96 Lane change assist does not work, DTCs C1114F0 and C1114F3 stored in lane change assistance control modules

96 19 37 2048470/2 April 17, 2019. Supersedes Technical Service Bulletin Group 96 number 17-18 dated August 4, 2017 for reasons listed below.

Model(s)	Year	VIN Range	Vehicle-Specific Equipment
Q5	2018	All	With Audi pre sense

Figure 2. Bracket part number located on driver's side.

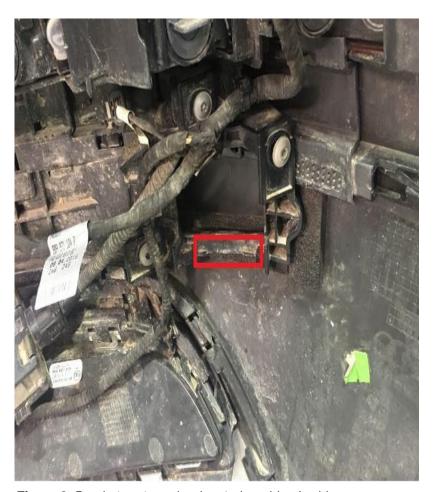
Before removing the bumper, check the bracket part numbers (Figure 2 and 3). If they are not part numbers 80A 907 908 B and 80A 907 907 B then proceed with the instructions below.

Prepare the new brackets 80A 907 908 B and 80A 907 907 B by applying the foam strips 80A 807 549.
